FmcAdc100m14b4cha modifications

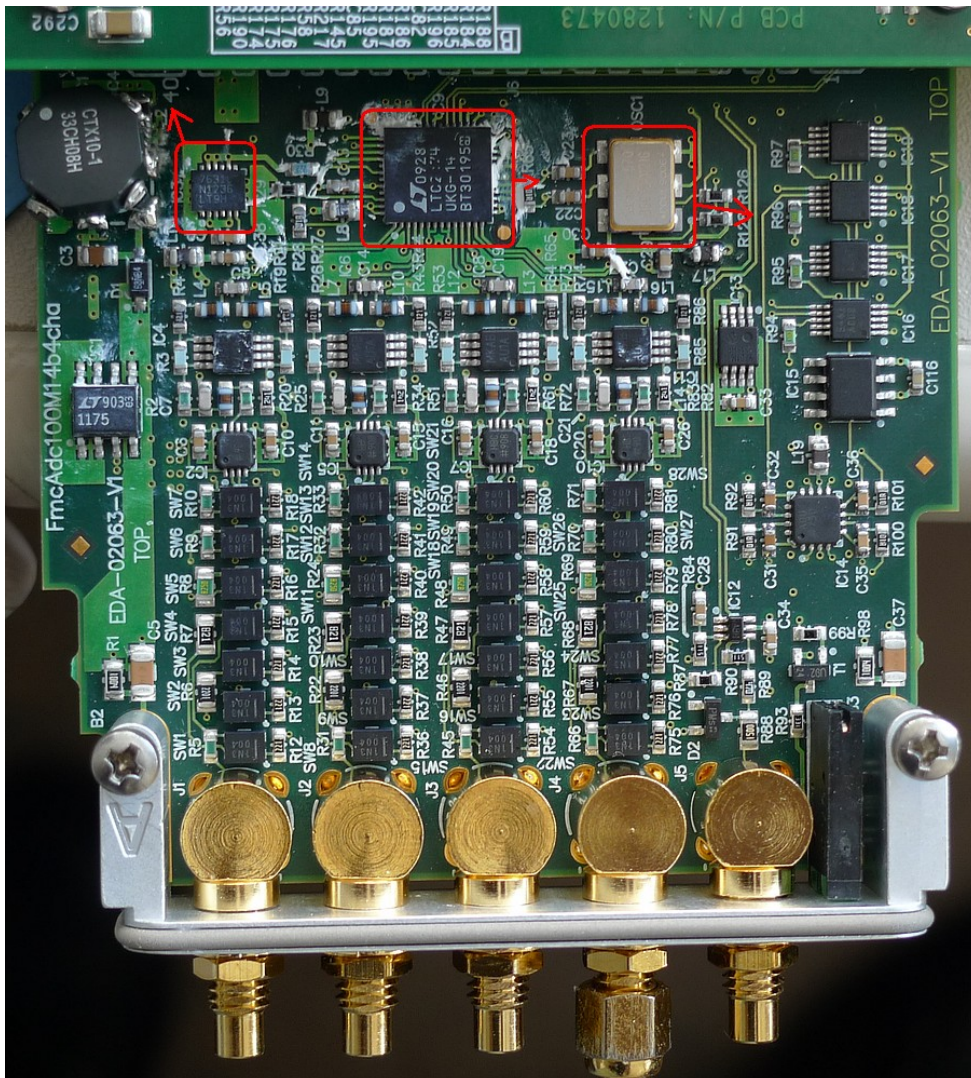
2. Some changes on the schematic. Different way of connecting front panel to the ground.
3. Resistors in series with LT3080 6 V linear regulator. Two 47 Ohm, 2512 size resistors connected in parallel (to have 23.5 Ohm). Don't forget about the decoupling capacitors at the input of the regulator.
4. LT3080 needs to be moved to less warmed up side of the board:
